Rolling Knolls Landfill Superfund SITE
FIELD CHANGE REQUEST (FCR) FORM

Contract No.:REQUEST NO: 08 DATE: 06/09/2015 (revised 06/18/2015)
(revised 06/24/2014)FCR TITLE: Replacement of MW-13 with Pore-water Samplers**DESCRIPTION:**

FIGURE
1

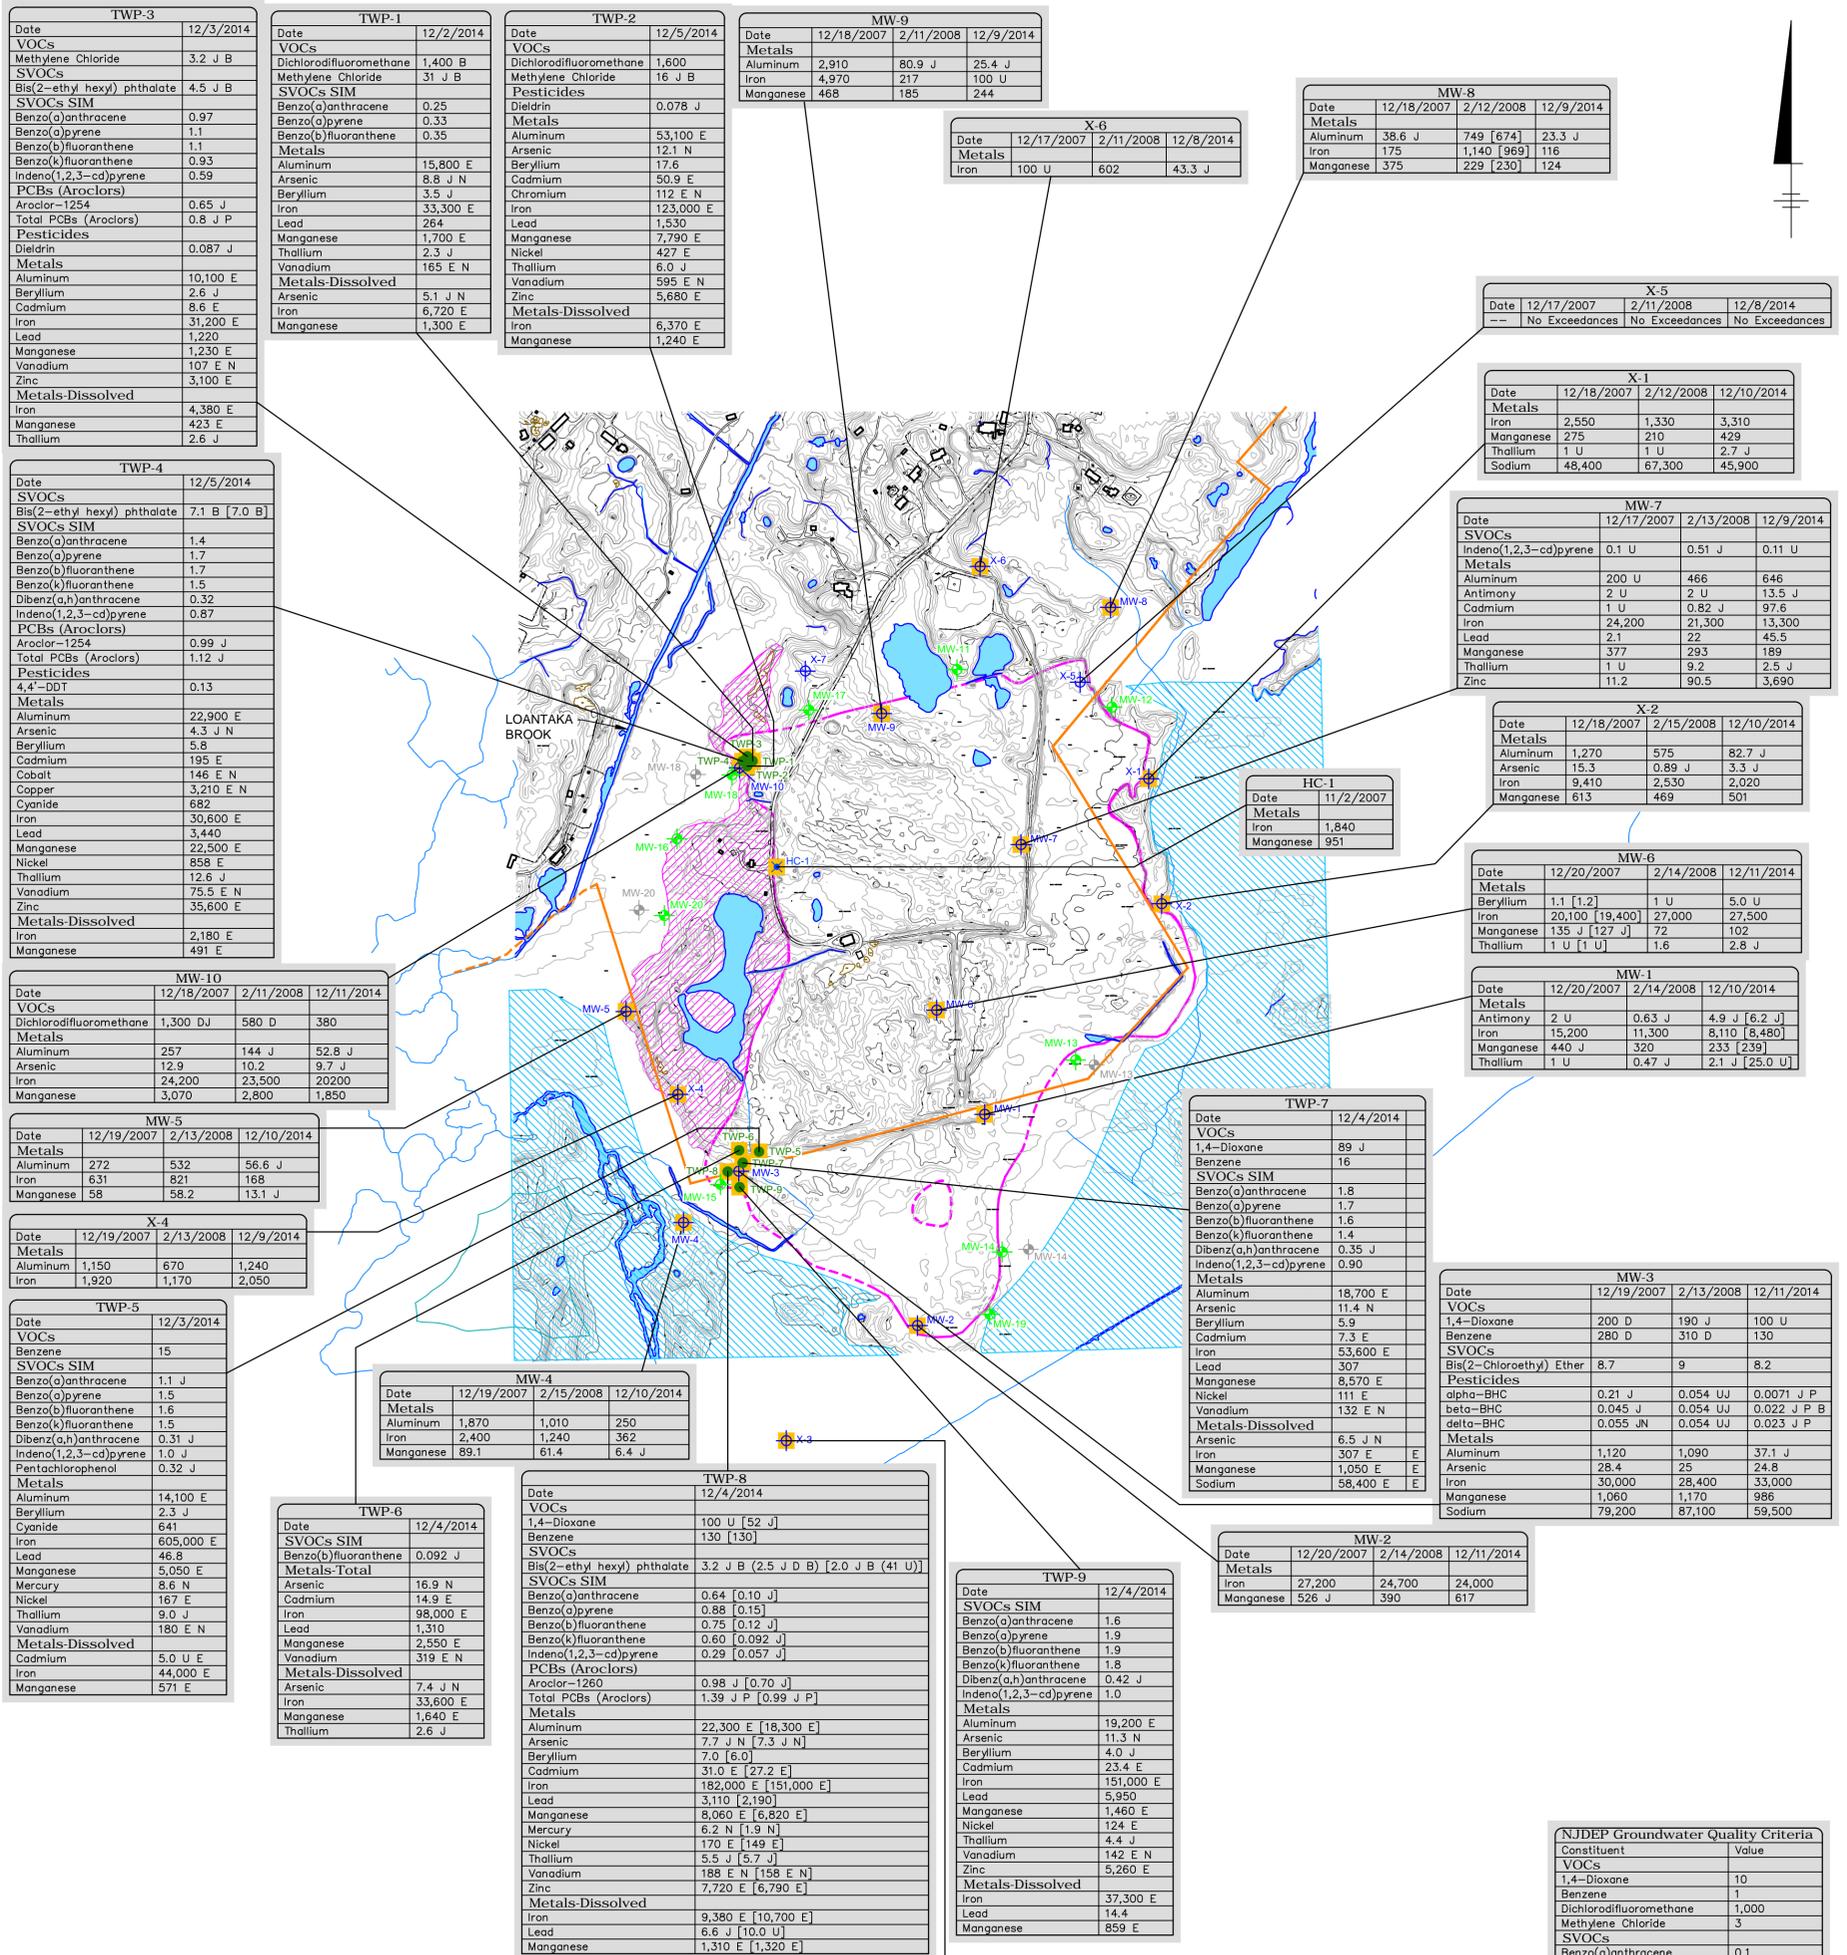
The Data Gaps Sampling and Analysis Plan (Data Gaps SAP) proposed installing seven permanent monitoring wells (MW-11 through MW-17). The Data Gaps SAP indicated the final locations of the permanent monitoring wells will be determined based on the results of the soil sampling and the temporary monitoring well samples collected as part of the data gap sampling. These data, and a proposal for the locations of the permanent monitoring wells, were transmitted to USEPA for review and approval on February 17, 2015. Additional supporting information was transmitted to USEPA on February 27, 2015. The USEPA responded on March 5, 2015 and requested adjustments to the locations of MW-12 and MW-15. The USEPA also requested the installation of three additional monitoring wells (MW-18 through MW-20). One of the proposed monitoring wells (MW-13) was to be located in an area later found to be inundated with water and is not a suitable location for a permanent monitoring well. Additional locations have been investigated; however, no appropriate relocation for this well has been identified. Consequently, the USEPA requested that pore-water samples be collected in place of this monitoring well.

Prior to installing the monitoring wells, ARCADIS personnel and a USEPA representative inspected each proposed monitoring well location. The proposed location for MW-13 was in approximately 6 to 24 inches of standing water. The location could not be moved to an area with no standing water, while still meeting the objective of delineating soil sample results from SS-157 and SS-158. USEPA was informed of these field conditions on May 28, 2015. As a result, on June 4, 2015, the USEPA requested pore-water samplers be placed at the MW-13 location, shown in green on Figure 1.

Monitoring well MW-13 will be replaced with porewater samplers. Regenerated cellulose membrane samplers will be used to collect volatile organic compounds (VOCs), metals (unfiltered only) and cyanide. Additional pore-water will be collected using PushPoint techniques and analyzed for semi-volatile organic compounds (SVOCs), pesticides, and polychlorinated biphenyls (PCBs) (as Aroclors). Certain SVOCs will be analyzed by SIM to obtain a lower detection limit. Sampling procedures will follow those approved in the Quality Assurance Project Plan (approved by USEPA on December 18, 2014) using standard operating procedures (SOPs) 20 and 21. If the pumping rate in the PushPoint samplers is low, it may be difficult to retrieve all the required volume for sample analysis within a sampling period of one 12-hour field day. In that case, the following order of priority for analyses will be used, as listed in Table 1 of the Data Gaps SAP for previously proposed pore-water samples (approved by USEPA on November 18, 2014) unless otherwise noted:
